What's wrong with the revised hydro schemes in Glen Etive – the Allt Mheuran

The Revised Allt a Mheuran Hydro scheme in Glen Etive – overlay by Tim Parkin

The revised Allt a Mheuran Scheme

The current bridge to Coileitir is narrow and blends in quite well to the surroundings – the new bridge on the left

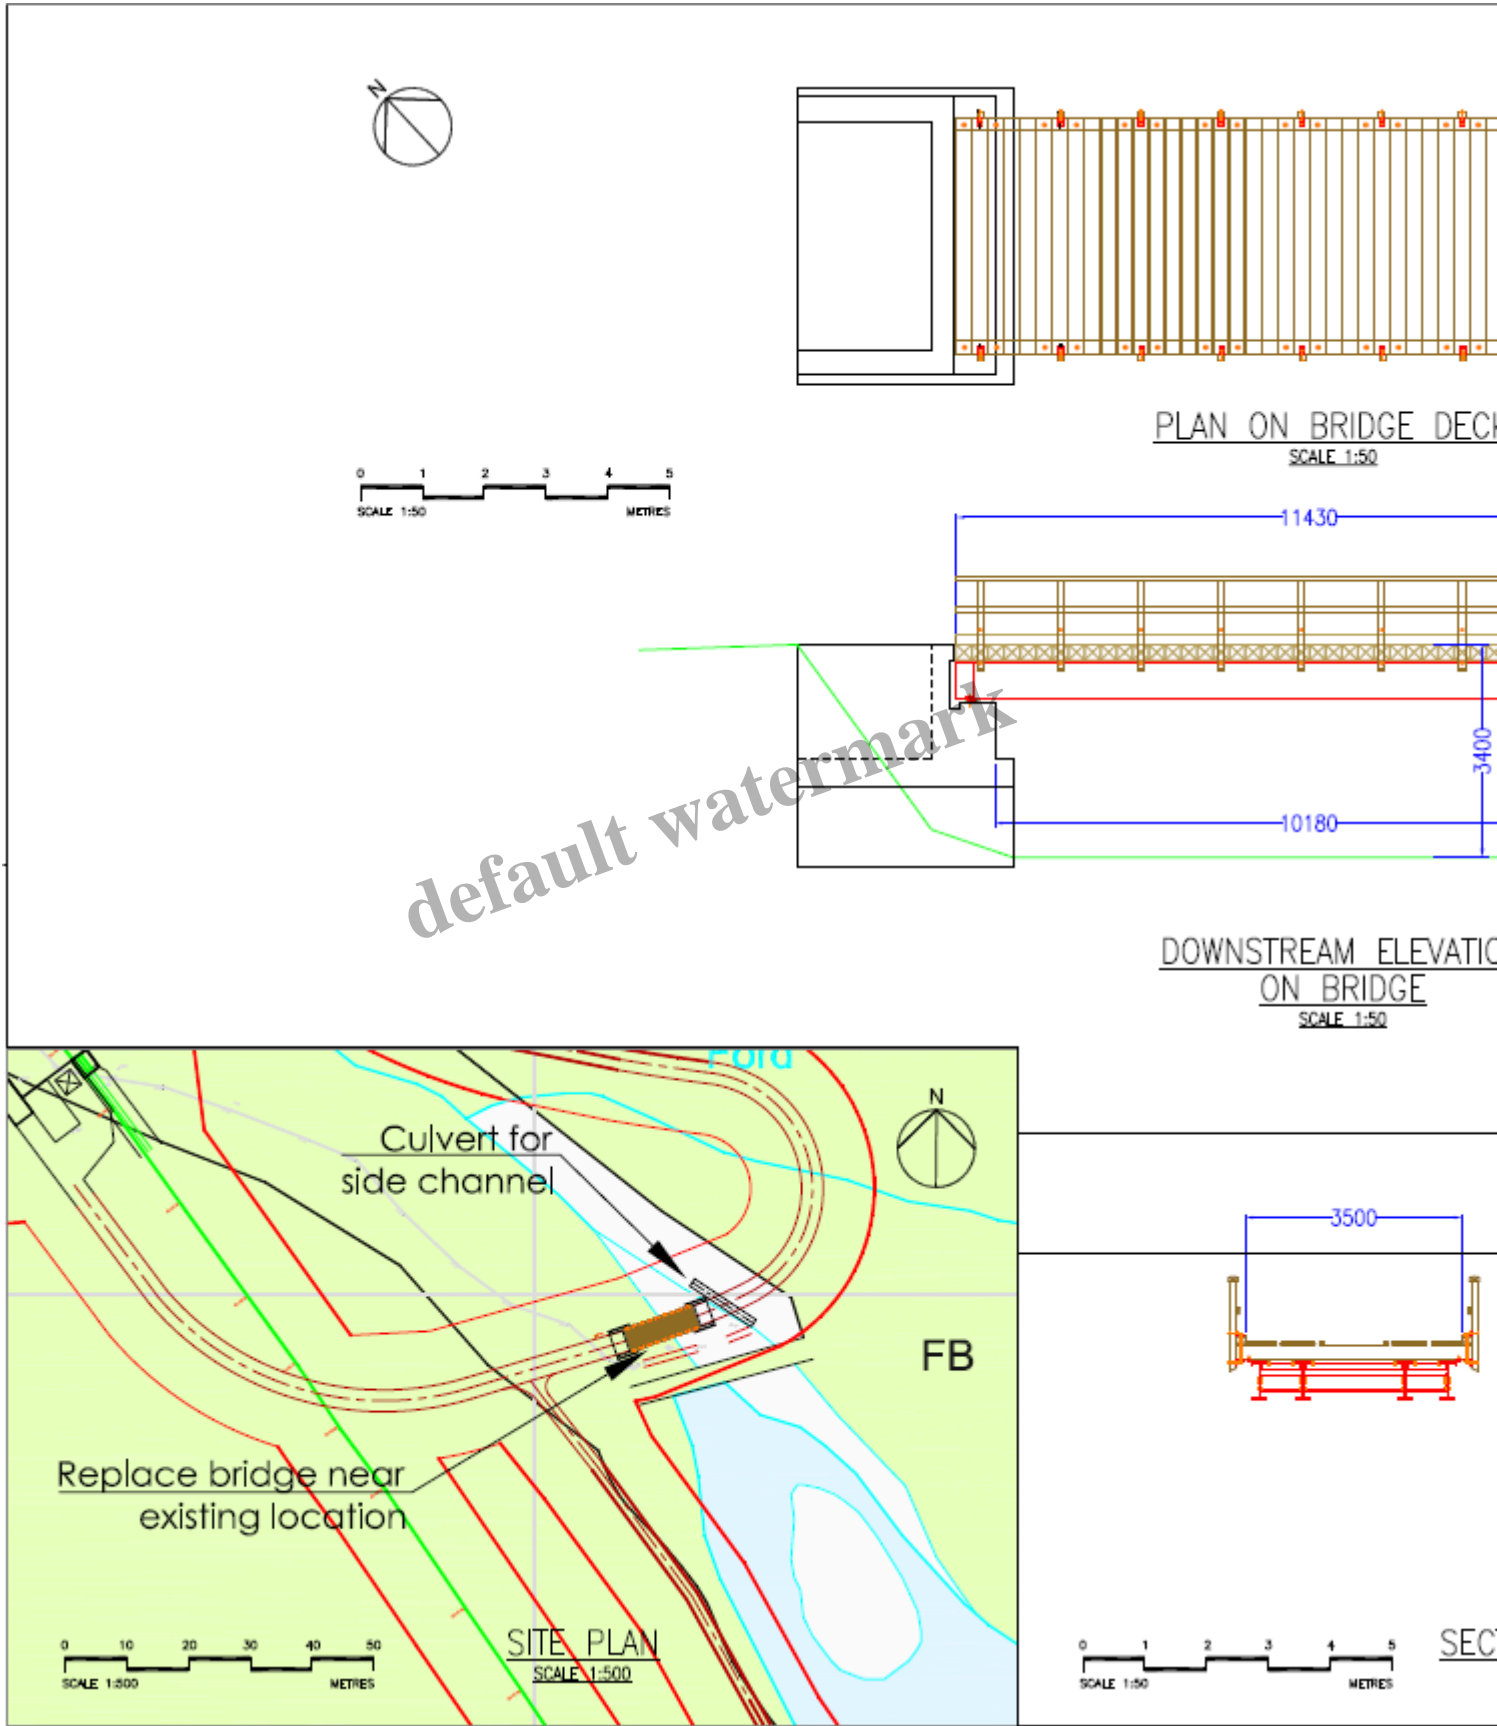
The proposal is to build a new bridge at Coileitir on the north side of the existing bridge. Following objections from SEPA, the revised plans now state the old bridge will be demolished and totally removed from the site. I can find nothing in the plans to say how many trees would need to be felled,

how the new bridge abutments would be constructed, their appearance (concrete?) or how the design of the bridge will fit the surroundings:

That is not acceptable for a significant new structure in a National Scenic Area.

Looking down the Allt Mheuran from the foot bridge. A permanent new road is proposed to follow either side of the river downstream from here.

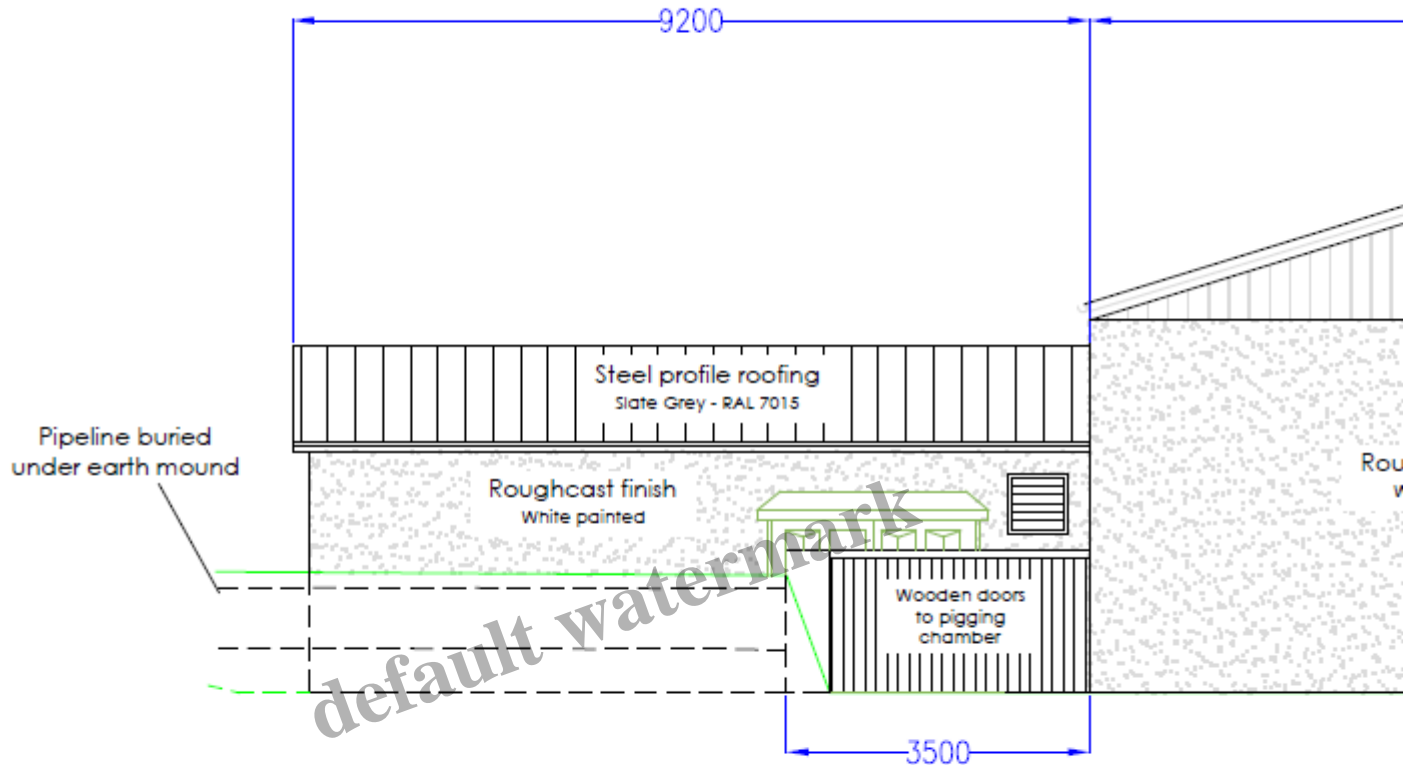
The new road is likely to obliterate the existing footpath and completely change the recreational experience.

The footbridge over the Allt Mheuran will be replaced by a vehicular bridge, which will not only change the character of the experience, it will open up a much wider area to vehicle mis-use.

Dickins Hydro have almost completely failed to assess the impact of the proposed new road on the landscape or the recreational experience, including the impact on Wild Land. (The zones of Theoretical Visibility Assessments have not been revised to take account of the change in plan or past deficiencies). This in itself should be sufficient for Highland Council to reject the application.

Fig 3. Penstock excavation process for working within half of the 20m corridor

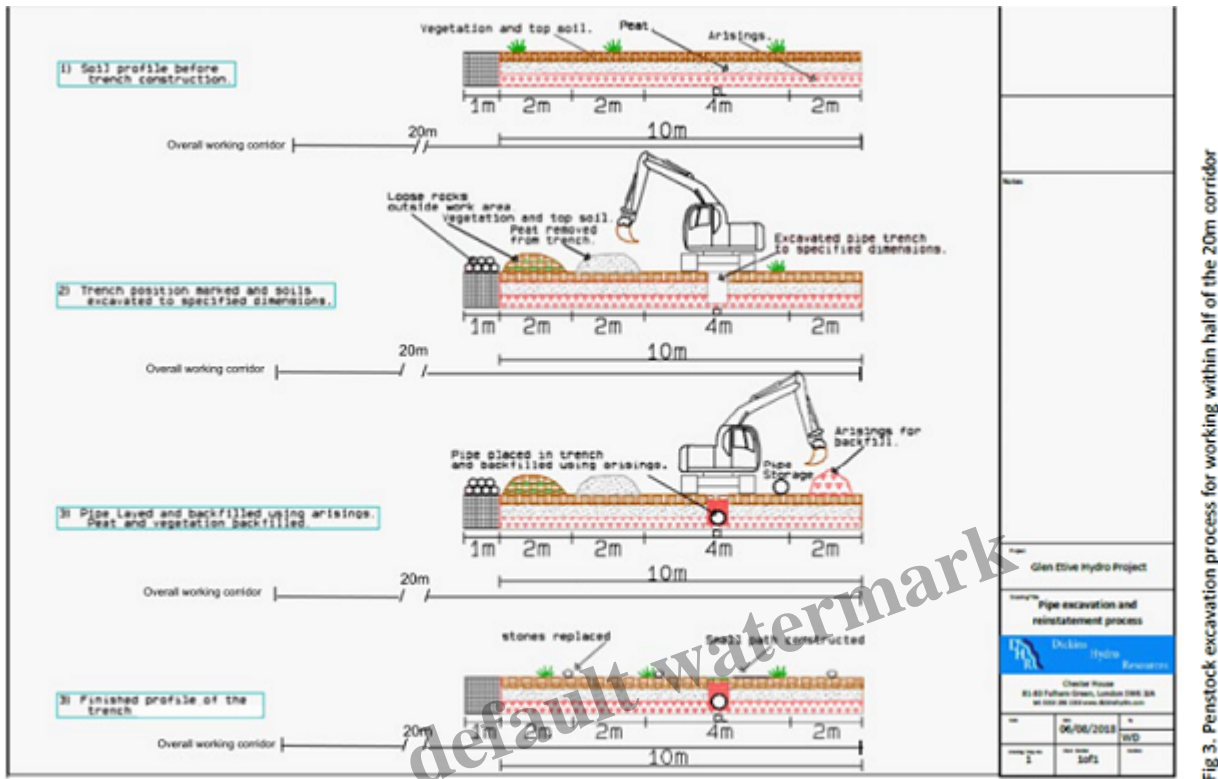
boulders have been moved and shaped by the Allt Mheuran and its not difficult to detect a number of previous courses taken by the river. Neither the Environmental Impact Assessment or Dickins Hydro's new construction method statement say anything about this "fossilised landscape". Their proposals for excavating and restoring the pipeline are completely inappropriate here:

Dickins Hydro will NEVER be able to bury the pipeline here in the way described on this type of terrain.

Issue: public concerns permanent access tracks at Mheuran Hydro in regard to the initial planning application.

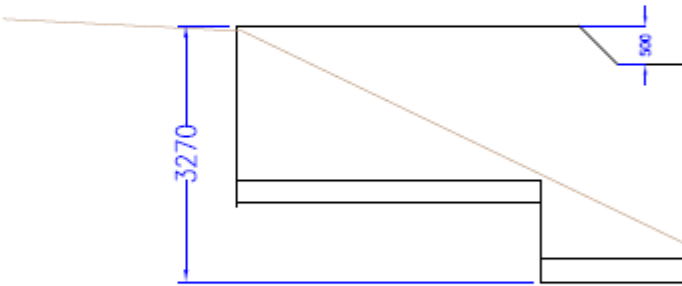
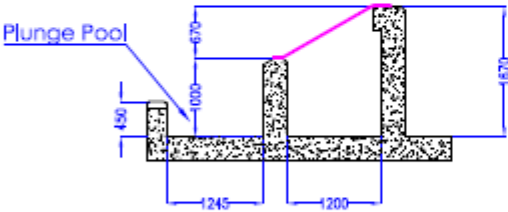
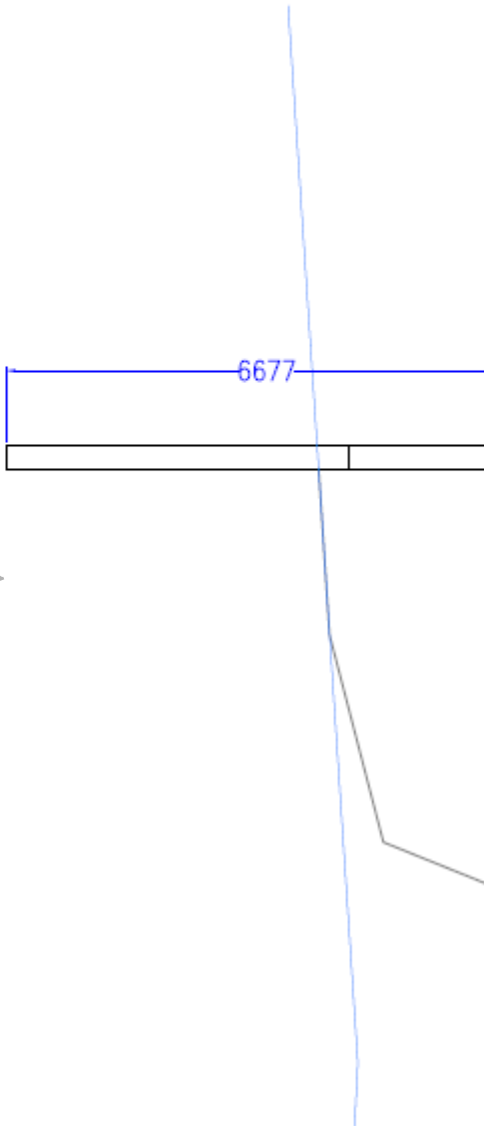
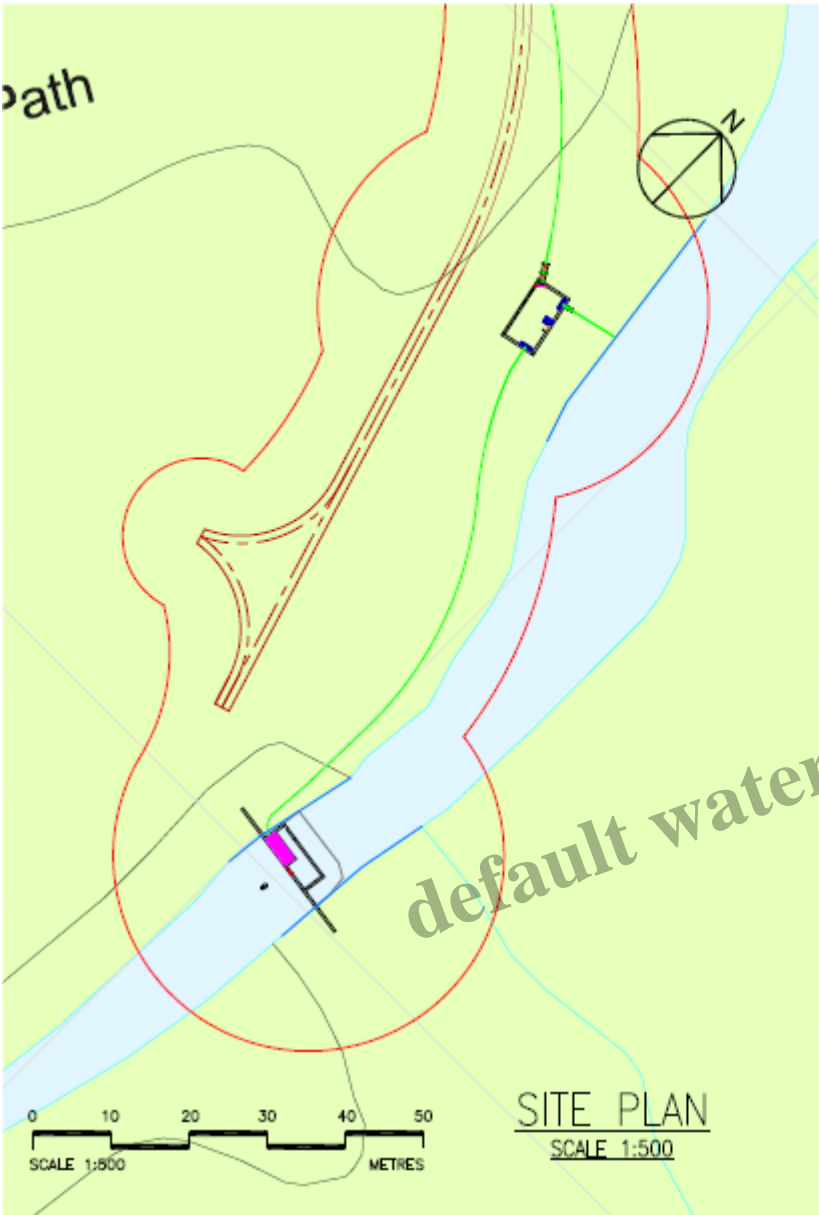
One of the biggest changes in the new Planning Application is that it now proposes that the construction track between the bridge over the Allt Mheuran to the intake should be fully restored. That sounds promising until you consider that if burying a pipeline here poses enormous challenges, creating and then fully restoring the construction track will be even more difficult. The revised application makes light of this:

This is either a deliberate attempt to mislead or wishful thinking based on a failure to look at the terrain properly. Highland Council should not accept this but instead demand detailed plans showing exactly where the track will go and how Dickins Hydro's specialist re-instatement team propose to restore the ground before the application goes any further.

Solution: We have considered the objections posted regarding access tracks to the intakes. As previously mentioned in the constrains (sic) plans and CMS [construction method statement] which indicated that these tracks would be reinstated to ATV access tracks post construction . With the exception of Mheuran Hydro where the access track to the intake will be fully restored to the previous landform..... This means that once fully reinstated it will leave the access similar in appearance to what is there at present, once regeneration has taken place. The appointed LCoW [landscape clerk of works]will lead a specialist qualified reinstatement team ensuring that reinstatement is carried up to the highest standards.
